Executive Summary

New York City (the City) is uniquely positioned in the investigation and remediation of the Newtown Creek (the Creek) Superfund Site (the Site or Study Area), acting as a stakeholder representing the interests of the local public and identified as a Potentially Responsible Party (PRP) by the US Environmental Protection Agency (USEPA). From this standpoint the City generally supports the Early Action (EA) in the East Branch (EB) as a potential opportunity for an expedited and effective clean up, but has several concerns regarding various elements of the proposed EB EA. The City's concerns center on the Remedial Action Objectives (RAOs) for EB, as well as the rest of the Creek (designated Operable Unit 1 [OU1]), and the cleanup goals set for EB and OU1. It is important to address these concerns to 1) avoid potential failure of the EA via recontamination of the remediated area and 2) to be consistent with USEPA guidance for Superfund cleanups. The concerns include:

Specific comments below follow the USEPA summary document provided to CSTAG:

Figure 1a – TPAH 34 Concentrations in NAPL Migrating to the Study Area

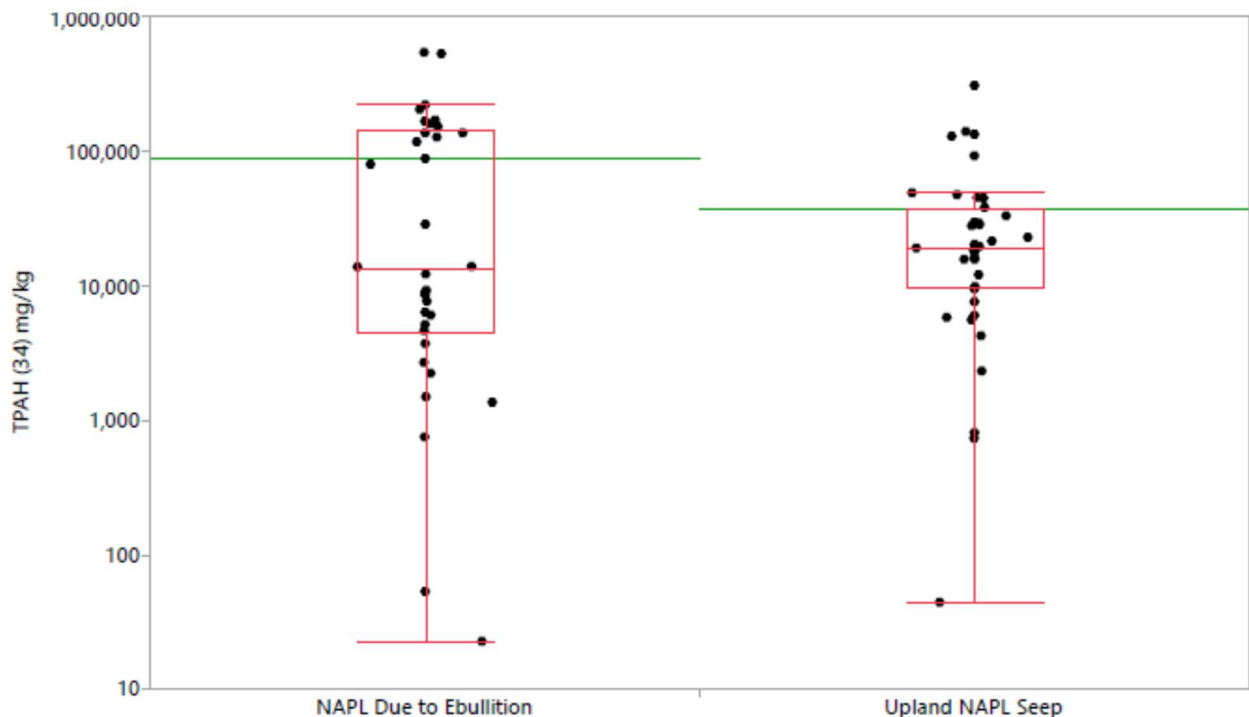
Data collected by the City shows that the NAPLs entering the Creek have COPC concentrations that are orders of magnitude higher than the risk-based PRGs. **Figures 1a-c** below show the concentrations of the COPCs in NAPL migrating from upland properties and from sediments of the Creek due to ebullition. As shown in the figures below, the concentrations of COPCs in the NAPLs are very high. On average the TPAH34 concentrations in NAPLs seeping in from upland Sites is about 100,000 mg/kg, average TPCB is approximately 100 mg/kg and average C19-C36 aliphatic petroleum hydrocarbons concentration is approximately 400,000 mg/kg. These concentrations are comparable to the concentrations in NAPLs migrating due to ebullition. Although there is a specific plan to control NAPL migrating through the sediments as part of the source control RAO, NAPL from upland properties is not targeted, despite the elevated concentrations. This is in direct contrast with other Superfund Sites where reducing or eliminating NAPL migration from all sources, including uplands, is a RAO.

Figure 2a Comparison of Anthropogenic Background/IPM/LTE to Risk PRGs – TPAH 34

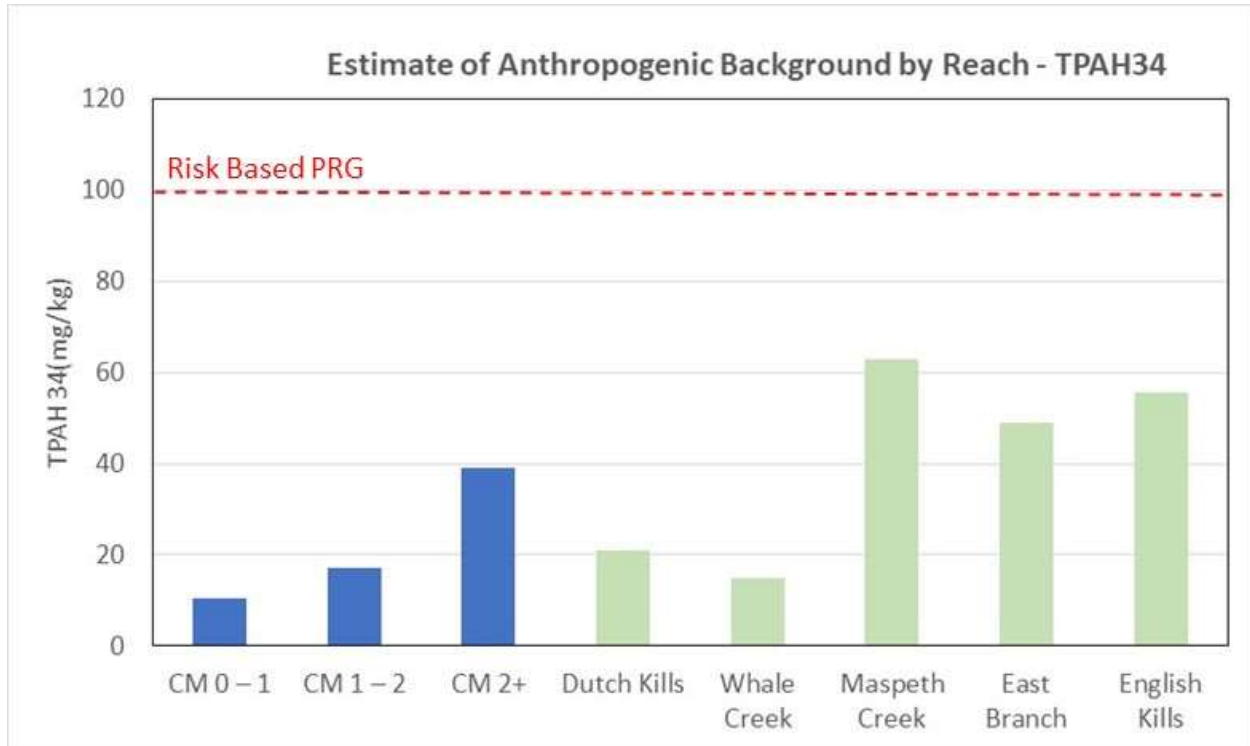
3) Use of Interim Performance Measures instead of Anthropogenic Background: The EA documents seem to refer to anthropogenic background for the Creek as Interim Performance Measures (IPM). An excel-based model has been used to estimate the Long-Term Equilibrium (LTE) concentrations in the surface sediments of the Creek after the entire Creek has been remediated and any ongoing sources to the Creek would continue. The only ongoing sources to the Creek included in this model are point sources, the East River, eroding shorelines, atmospheric deposition, and groundwater (assumed to be uncontaminated). NAPL migration – both from within and outside (i.e. upland seeps) the Study area is not considered as an ongoing source to the Creek for this calculation. This calculation is effectively the anthropogenic background for the Creek after remedial action has taken place. **Figures 2a-e** below presents a comparison of the risk-based PRGs with the anthropogenic background for the Site calculated for each Creek reach using available data for the RI/FS. As shown in the figure, the anthropogenic background for the contaminants of concern is at or below the risk-based PRGs for all contaminants except Total Dioxin/Furan TEQ. Even for Total Dioxin/Furan, the risk is significantly reduced if the Site is at the anthropogenic background. The entire New York harbor currently poses risk due to elevated Total Dioxin Furan TEQ concentrations in the sediments, as demonstrated by the concentrations at reference areas selected for risk assessment for the Site. Testing at the four waterbodies, Westchester Creek, Gerritsen Creek, Spring Creek and Head of Bay, representative of the urban areas in the NY harbor show presence of toxicity to human health due to elevated concentrations of TPCB and Total Dioxin Furans in sediments.

As per USEPA guidance (USEPA 2002), the CERCLA program does not set cleanup levels below anthropogenic background concentrations. Setting the PRGs for this Site at the risk-based values and not the anthropogenic background goes against USEPA guidance. Instead, an unprecedented approach of calling the anthropogenic background an IPM is applied. No definition of what “interim” represents has been provided. The approach also states that, “EPA expects loading from ongoing sources to decrease over time due to improved BMPs in general, ongoing cleanup actions, and additional regulatory control.” in support of using an “interim measure”. While in general this statement is true and COPC concentrations can be expected decrease over time, the rate of decrease is unknown and has been not quantified. It is not clear from this approach when the Site is expected to achieve the risk-based PRGs for chemicals where the anthropogenic background is above the risk-based PRG.

Figure 5a – TPAH concentrations (mg/kg) in Point Sources, Superfund Sites, and Regional Waterbodies

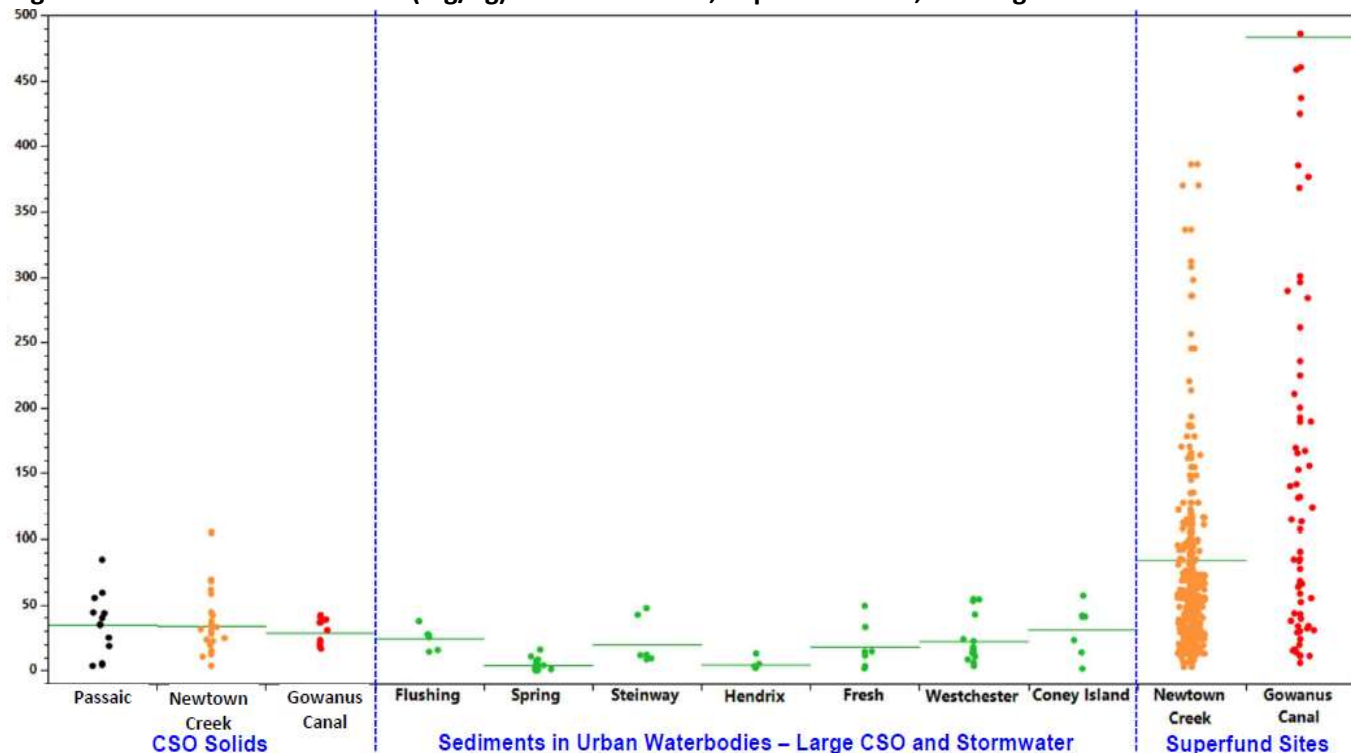
These data gaps are not unique to the EB portion of the Study Area. Data gaps associated due to lack of data for groundwater and NAPL entering through the intertidal zone are present for the entire Site. There is also significant uncertainty associated the loads associated with NAPL migrating due to the ebullition. This is largely driven by the poor understanding of the spatial extent of areas over which NAPL migration due to ebullition is occurring. The CSM and the CFT model compensates for the lack of characterization of these sources by attributing their impacts to point sources – especially CSOs and MS4s. For example, in the CFT model, the contaminant loads from groundwater and NAPL seeps entering the Creek from the intertidal zone are set to **zero**. The approach used in the CFT model to set the contaminant inputs loads to zero is incorrect for a site with obvious NAPL impacts. The CFT model is uncalibrated and its inability to predict the elevated concentrations in the sediment has been attributed to uncertainty in point sources.

Figures 5a-c below show the concentrations of contaminants measured in point sources compared to Creek sediments as well as other regional waterbodies. As shown below, the RI data collected for point sources and other Sites shows that the contaminant concentrations in point sources are low and have low variability. Point sources cannot explain the significantly elevated concentrations in the surface sediment of the Creek. This is further supported by the LTE analysis, which shows that if the point sources were allowed to continue, concentrations in the surface sediment of the Creek would be comparable to the risk-based remedial goals for most contaminants.
